Permit Number: 050839

has permission to single family home with addition of 344 sq ft porch deck, 480 sq ft living space,

RE: 65 Brookside Dr. (Permit # 050839/158 A014) Waiver request

Item:	Date	Quantity	Title
1	07/14/05	1 ea	SKA-01 through SKA-05

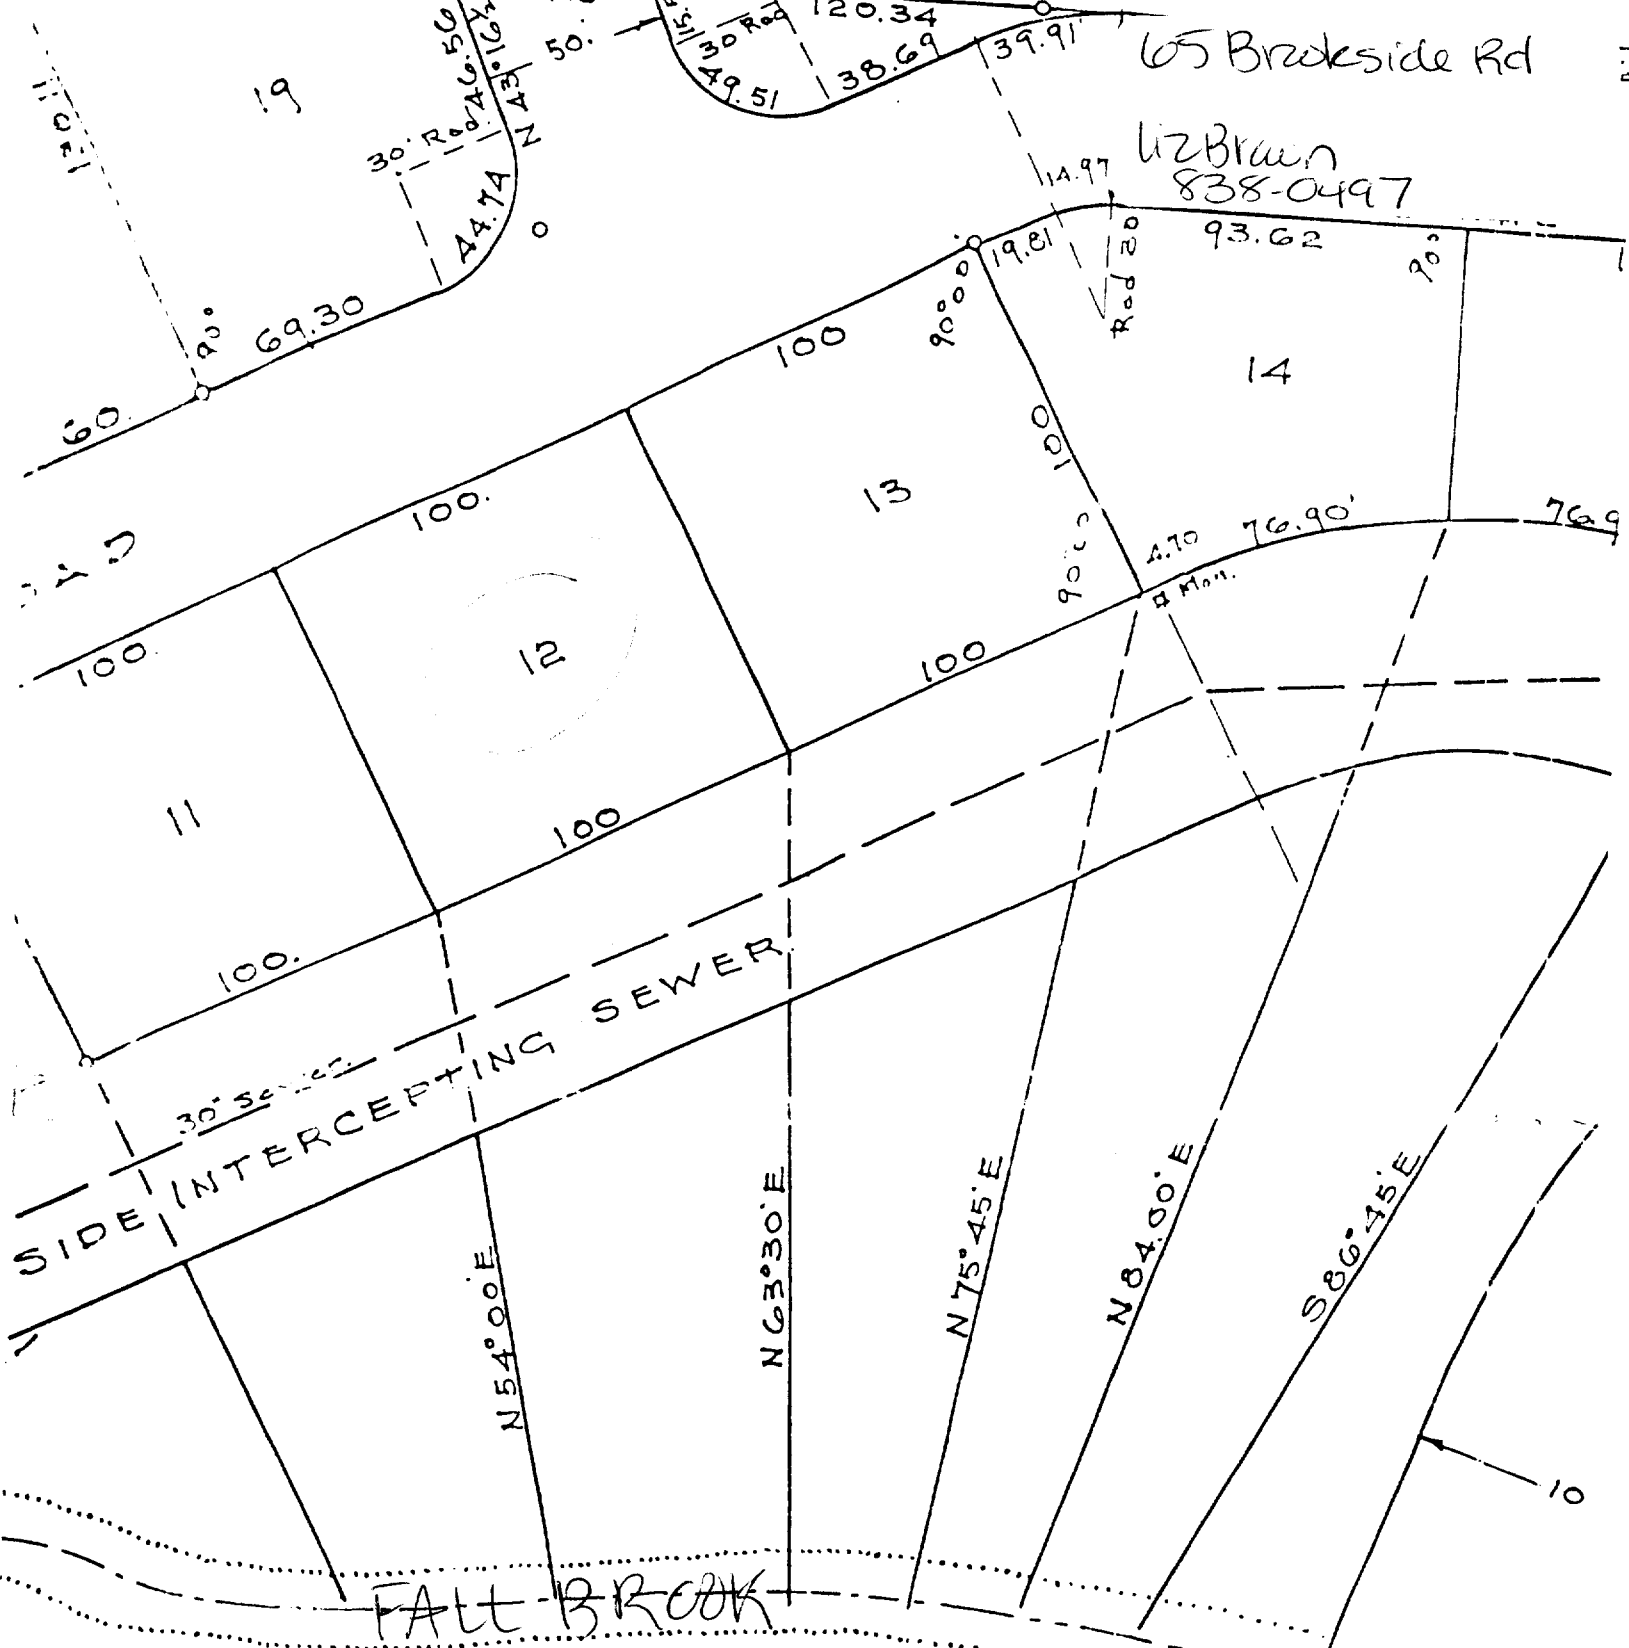
Type of Heating System		
<b>Means of Egress</b> (Sec R311 & R312)	ceiling HT? habitable? window well	No closets / NO bedrooms
Basement		
Number of Stairways		
Interior	?	Revisions 7/15/05
Exterior	'	
Treads and Risers (Section R311.5.3)		
Width (Section R311.5.1)	3'-6 7/8" - 3'-4 1/2"	
Headroom (Section R311.5.2)	?	6'8" scaled
Guardrails and Handrails (Section R312 & R311.5.6 - R311.5.6.3)	?	OK
Smoke Detectors (Section R313) Location and type/Interconnected	?	Noted on Finish 6.2A
Dwelling Unit Separation (Section R317) and IBC - 2003 (Section 1207)	N/A	
	Stamped ALL Plans Need Guards	Stamped 7/21/05

Need Guards
